Mayfield, Plot M ('Republic'), Manchester – Application for Amendments via Variation of Condition to Planning Permission for 137349/JO/2023

This covering letter accompanies an application for a variation of condition under Section 73 of the Town and Country Planning Act 1990, to amend Planning Permission 137349/JO/2023 in respect of Plot M within the Mayfield Strategic Regeneration (SRF) area.

Figure 1.1: Key Design Changes to External Façade and curtain walling

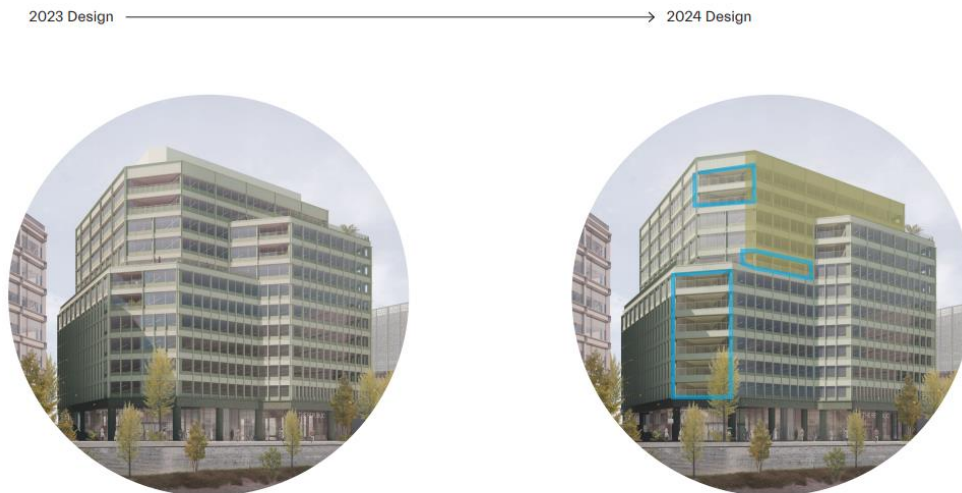
- **External Appearance:** To enhance the building's sustainability and commercial appeal, loggias have been introduced on levels 1 to 4, providing a direct visual connection to Mayfield Park. This design element has also been extended to levels 5, 6, 10, and 11, ensuring a consistent and attractive architectural feature throughout and to provide tenants on each floor with external amenity space. For improved functionality and safety, external loggia doors are now inward opening, with additional doors incorporated at the larger terraces on levels 7 and 10. The inclusion of the loggias results in a minor decrease in floorspace from 32,989 sq. m. to 31,988sqm (GEA; 1,001 sq. m. or 3% decrease).

- **Façade detailed design:** Updates to the detailed façade design have incorporated inputs from a specialist façade sub-consultant as well as further co-ordination with the consultant design team. The key change to the façade design relates to the delivery of a unitised system in order to improve the quality of finishes to the building envelope. The proposed façade system does not impact the architectural design intent or the external appearance of the consented scheme with fin depths being maintained, but does provide further carbon savings.
